SERVICE NEWS

DX7

BULLETIN NO. E-318

ROM Version Change

Mounting Diagram

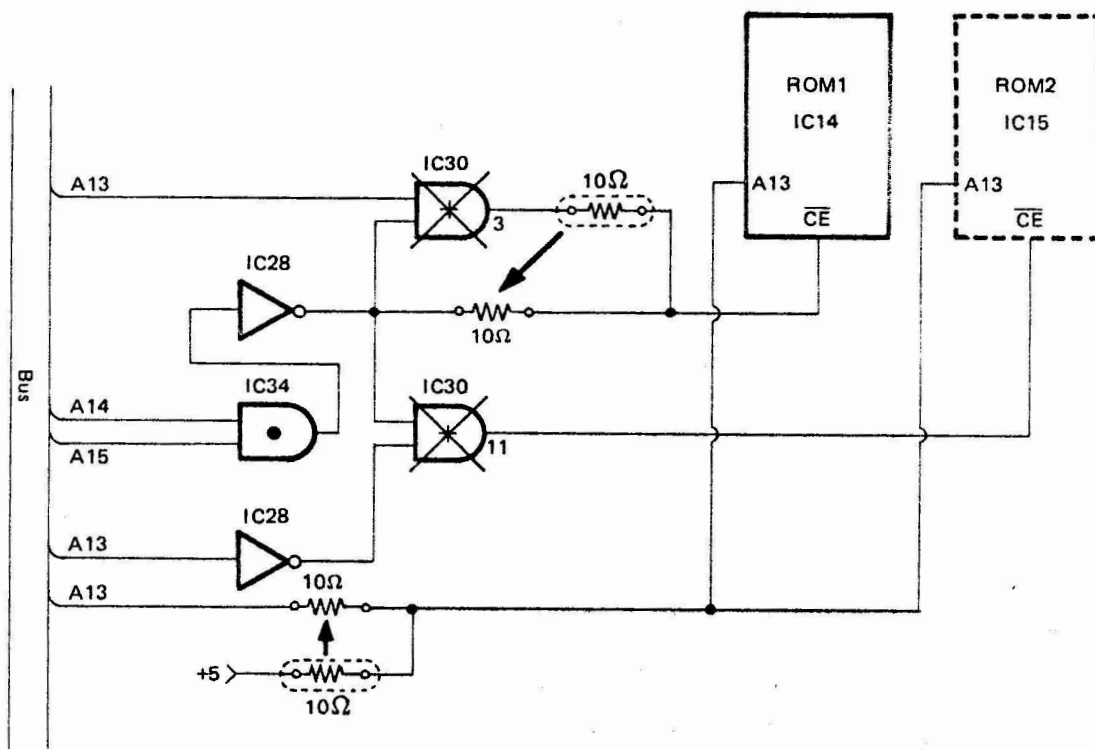
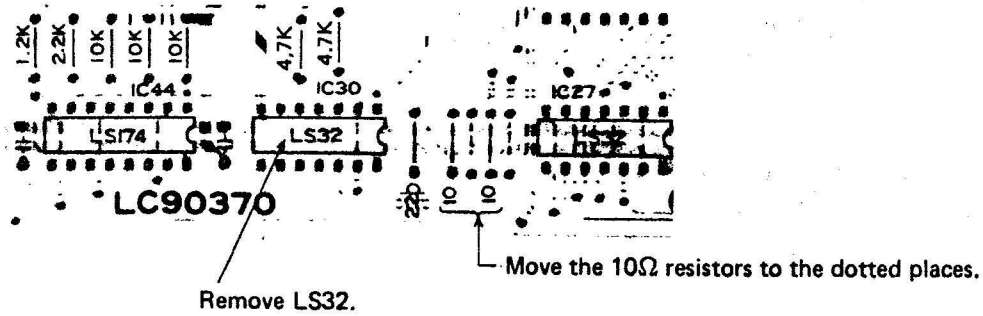
Since two 64 K EPROM's (IC 14 and 15) are employed in model before S/# 2660, the following circuit modification is required because of one chip 128 K MASK ROM employed in new model.

- (1) Remove ROM IC 14, 15 and IC 30 (OR gates).
- (2) Install MASK ROM at the place of ROM IC 14.
- (3) Change the locations of the two 10Ω resistors.
